22/0158/FUL New click and collect for IKEA

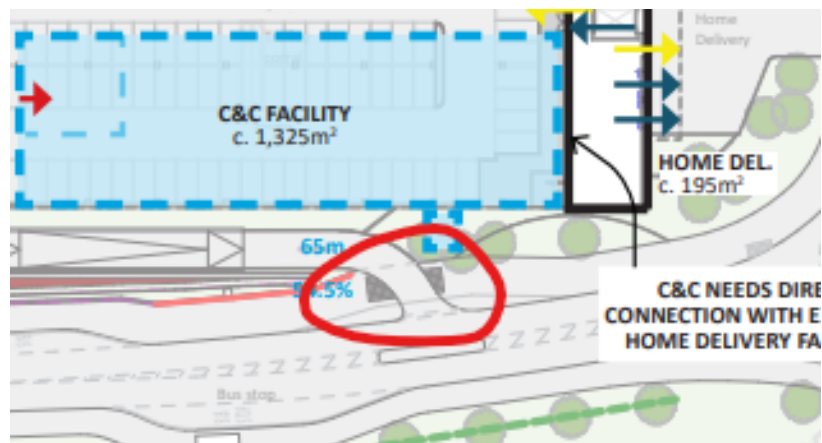
We have a **concern** that the additional traffic volumes these changes will build in conflict at the crossing point of the access road and the cycle path on the N side of IKEA Way.

The proposed exit from the click and collect facility cuts across at an acute angle the cycle & foot path by which people cycling and walking access the site.

Currently cars have priority at this junction over people walking or cycling.

We recognise that the volumes of people walking or cycling are probably currently low. However, a key principle of the government's 'Gear Change' strategy is that we need to be building for future walking and cycling volumes. We would ask therefore that consideration is given to changing the priority at this crossing junction so that cars have to give way to people walking or cycling. This priority needs to be well designed so that signs, surface, height and road markings make it clear that cars should give way.

LTN 1/20 contains guidance on how best to design such a side-road priority junction. We would ask that this is referenced in the design when improving this junction.

In order to align with these NPPF principles we suggest that the junction that gives us concern is redesigned.
